City of Albuquerque

Traffic Scoping Form (REV 07/2020)

Project Title: The 66			
Building Permit #: Hydrology File #:			
Zone Atlas Page: KIT DRB#:EPC#:	Work Ord	er#:	
Zone Atlas Page: K17 DRB#: EPC#: Legal Description: Block 44 Valley Viaux	Addition		
Development Street Address: 4501 cantral Ave N	E		
Applicant: Scott Anderson	Contact:		
Address: 4419 4+5+ NW 87107			
Phone#: 505 401 7575 Fax#: E-mail: Scott@ Scaarch: tects.com			
E-mail: scott@ scaarchitects.com			
Development Information			
Build out/Implementation Year: 2024 Current/Proposed Zoning: MK-M			
Project Type: New: (X) Change of Use: () Same Use/Unchanged:	() Same Use/Increased	Activity: ()	
Change of Zoning: ()			
Proposed Use (mark all that apply): Residential: (X) Office: () Reta	nil: () Mixed-Use: ()		
Describe development and Head			
96 unit apartment			
		E	
Days and Hours of Operation (if known):			
1			
Facility			
Building Size (sq. ft.): 95, 352			
Number of Residential Units:			
Number of Commercial Units:

THE SIXTY-SIX 4501 CENTRAL AVE NE ALBUQUERQUE, NM 87108

REFUSE ENCLOSURE

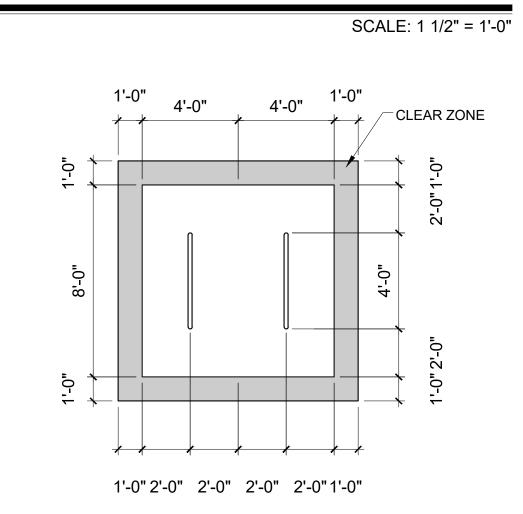
Approved for access by the Solid Waste Department for a double trash enclosure The refuse and recycle driver will be given gate clickers for the gates off of Copper. **The owner of this property will have to purchase an 8-cubic yard dumpster for trash.** Herman Gallegos 03-13-23 Herman Gallegos
